L-42 Information Letter 19-1
Sequence Number 36
February 20, 2019

SUBJECT: 1. Clarification of stand referencing procedure added to section 9.6.1
2. Figure A6.2 modified to better define the location of the axle cooling spray nozzles

(Revises Test Method D7452-17)

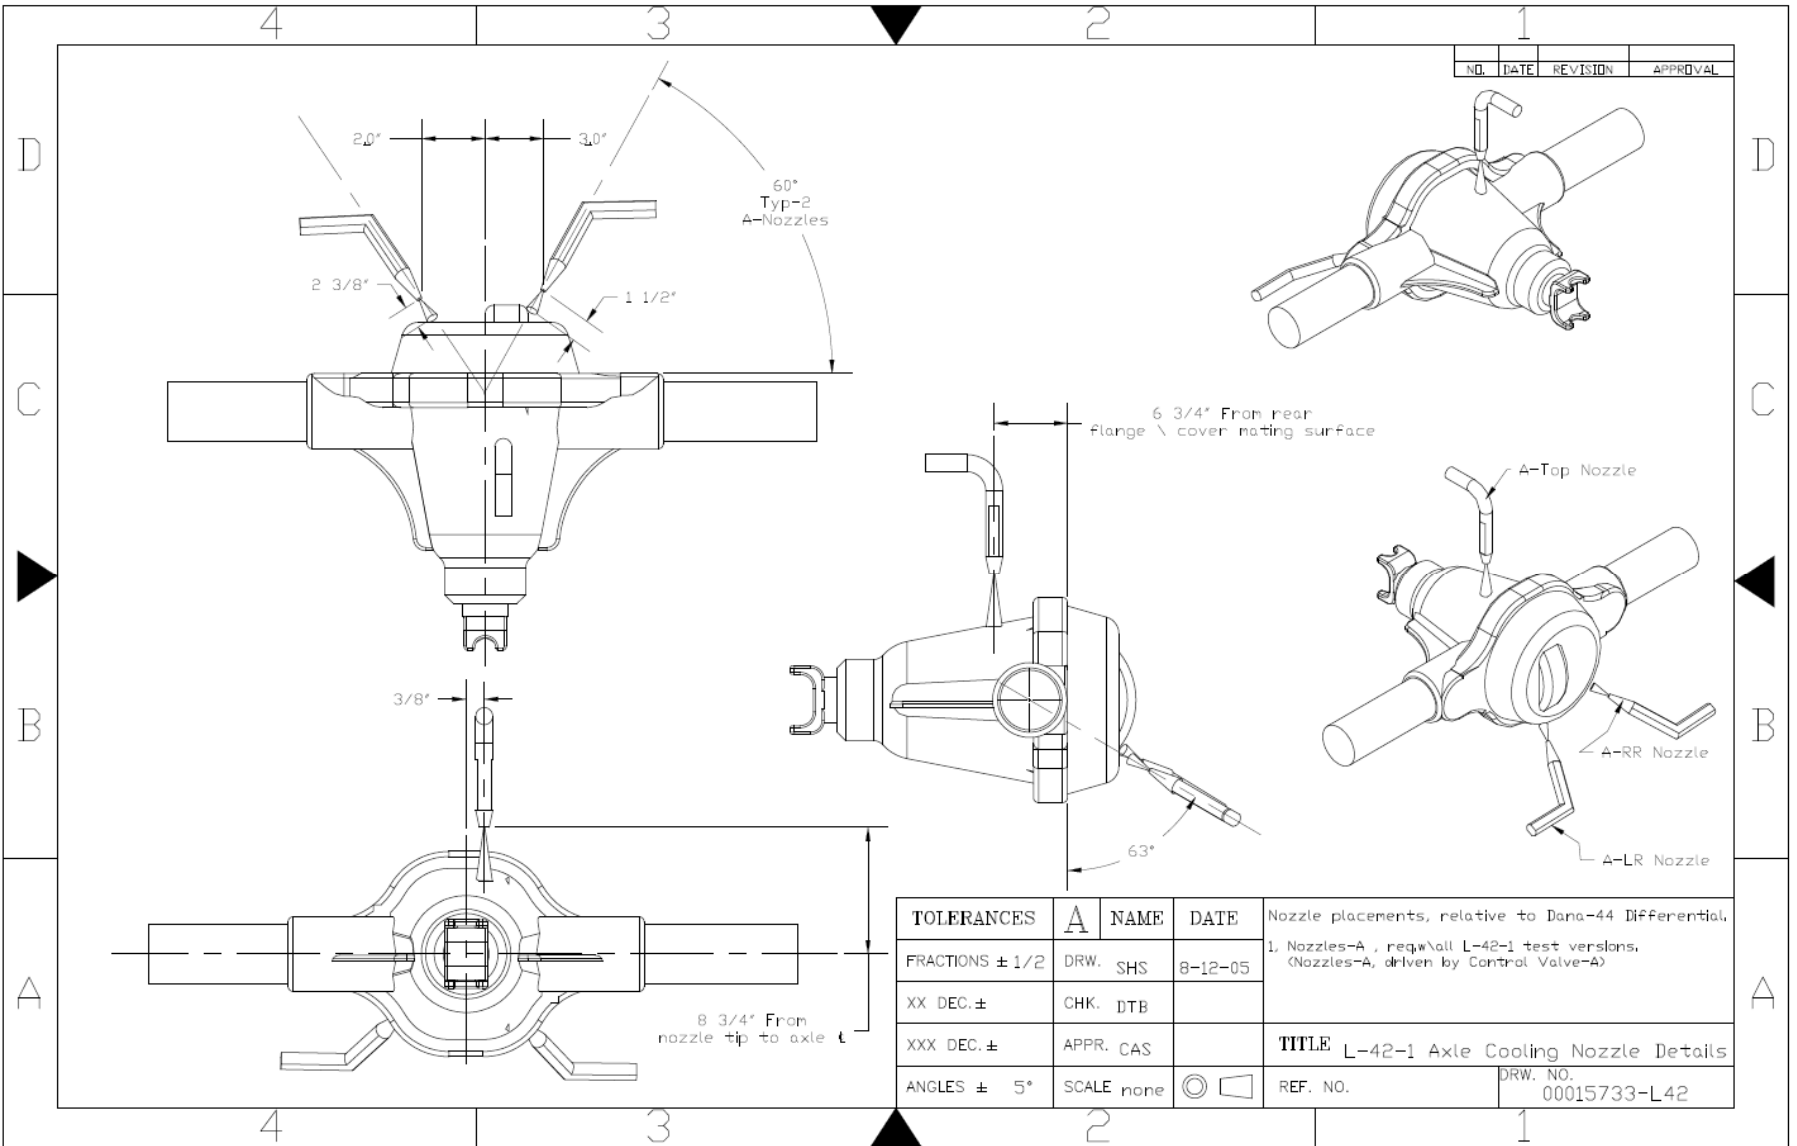
The L-42 Surveillance Panel approved the following changes at their February 13th, 2019 meeting. Clarification was added to section 9.6.1 to include the addition of a discrimination oil run to the calibration requirements if any of the special circumstances listed within the section occur. In addition, the graphic in figure A6.2 has been updated to further distinguish the location of the axle cooling spray nozzle.

Replace the graphic used in A6.2 with the one below.
